寄件者: [REDACTED]
寄件日期: 2026年4月17日星期五 11:33
收件者: tpbpd/PLAND
副本: Sheldon Ming Sum NG/PLAND; ADO TP PD/FSD
主旨: Response the FS Comment for Application No. A/I-TCV/30 (FINAL)
附件: Response the FS Comment for TCV_30.pdf; DD1TC 1386 FS PLAN_2026-04-17.pdf
類別: Internet Email

Response to the Comments from Fire Services Department:

Project 項目
D.D.1TC, LOT 1386RP,
1387, 1395RP

Application 申請
臨時商業及服務行業
(蔬菜及雜貨店)
連附屬寫字樓及貯物用途

Scale 比例	1:250 (A3)	Revisions 修訂	-
Designed by 設計者	LW	Drawn by 繪圖人	Arthur
Checked by 檢查	LW	Date 日期	16-APR-2026
Job No. 工程項目	-	Drawing No. 圖號	FS-01

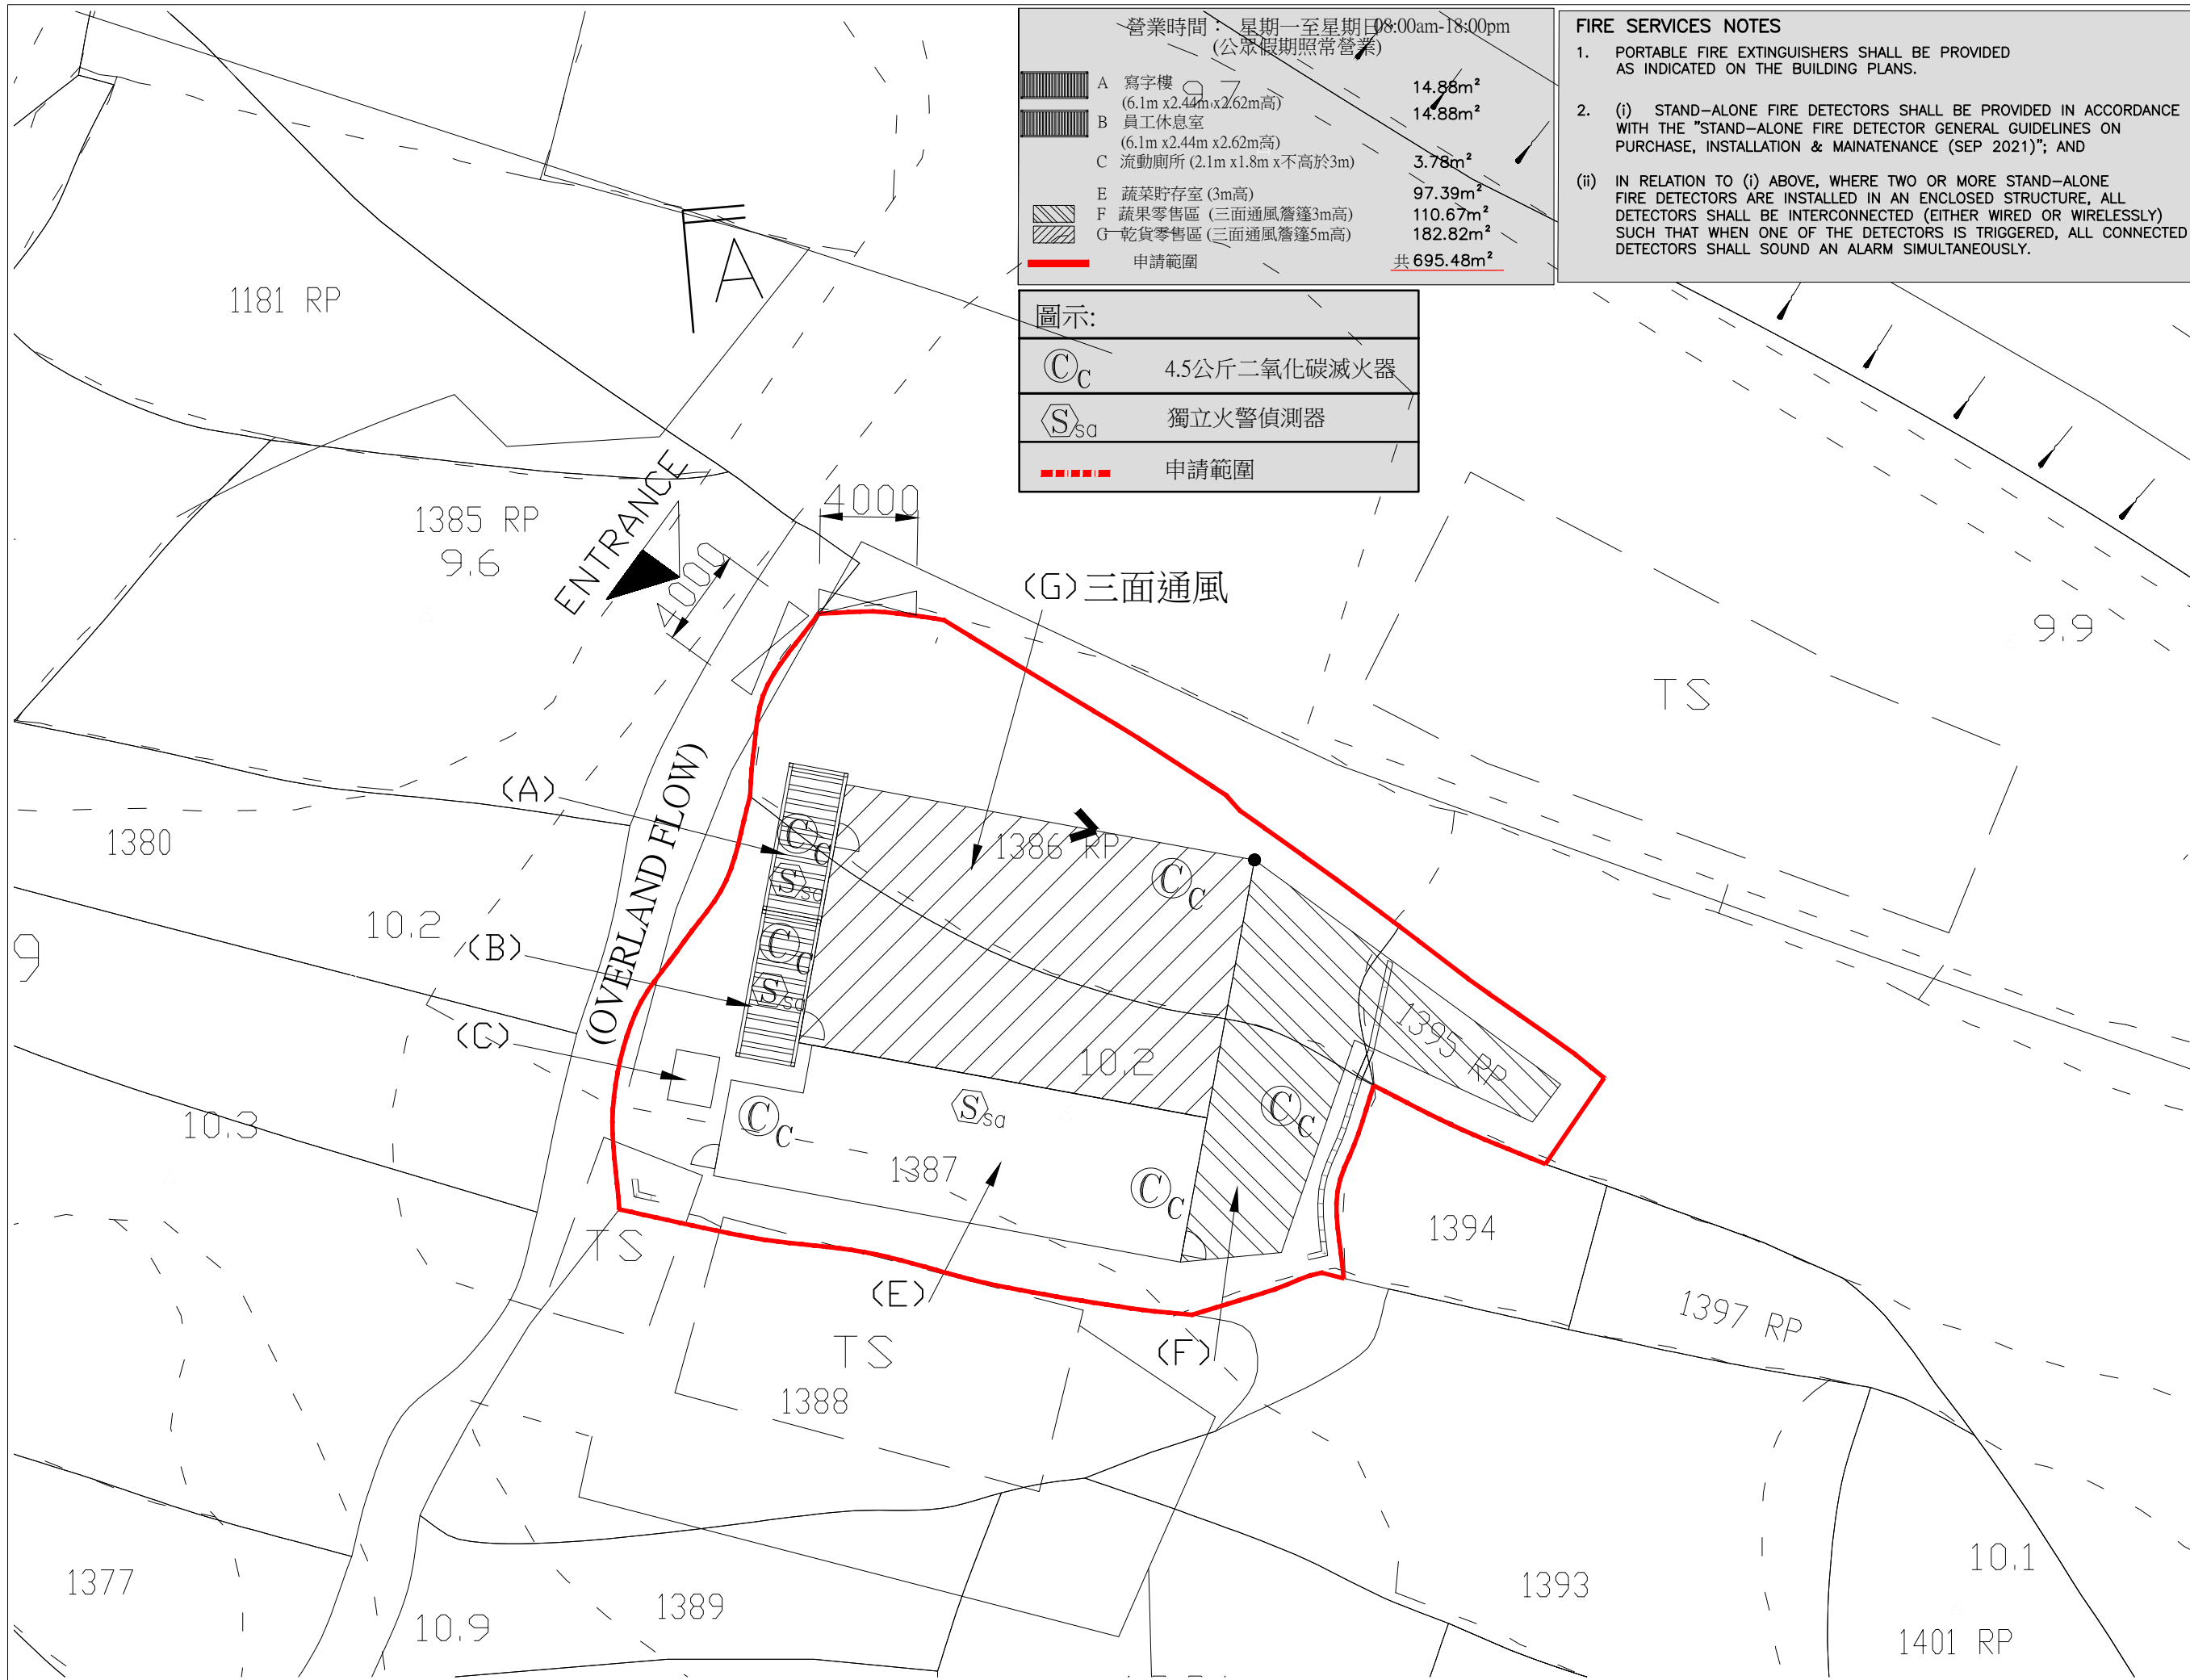
- i. Items 2 & 3 in the FS Notes shall be deleted if they are not applicable to the application; and

- ii. Structure F shall be clarified as to whether it is a shed with 3-side open.

[Noted and revised. \(see attached\)](#)

[Confirm the Structure F is a shed with 3-side open](#)
